DEVELOPMENT REVIEW BOARD REPORT

CASE NUMBER/
PROJECT NAME

37-DR-2006
Scottsdale Auto Salon

Request approval of a site plan, landscape plan and elevations to develop a full service car-wash and gasoline sales facility on a 4-acre vacant triangular parcel located at the Southwest corner of N. 94th St. and E. Bell Road.

Car Wash / Retail Building Elevations

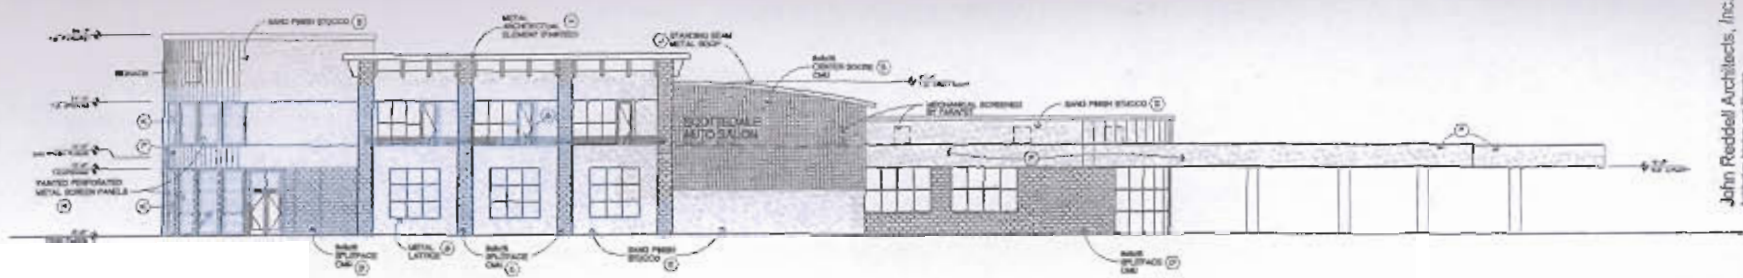
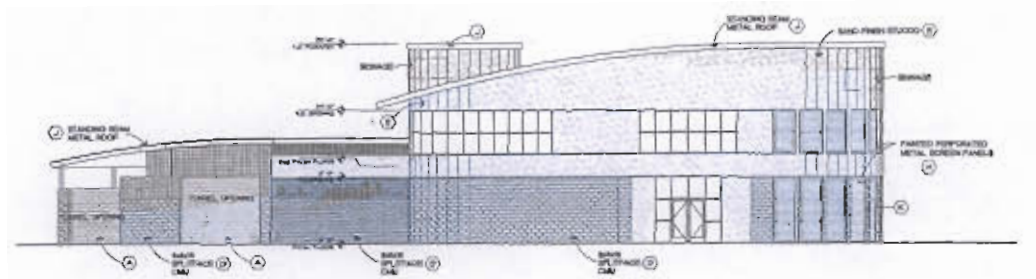
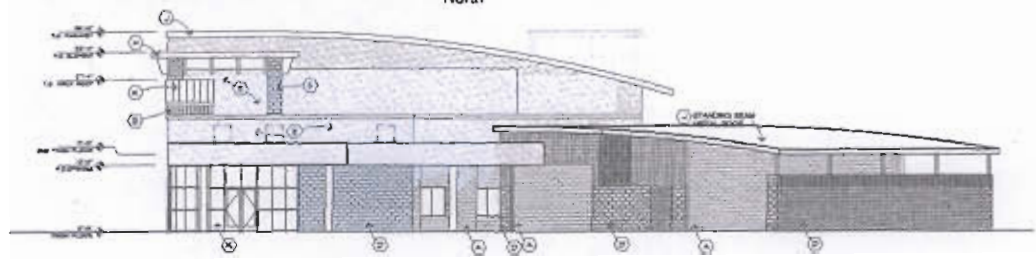
Architectural elements, including dimensions, materials, form, color, and texture, shall be constructed to be consistent with the building elevations submitted by LAVA Architects, Inc. with a submittal date of May 26, 2006.
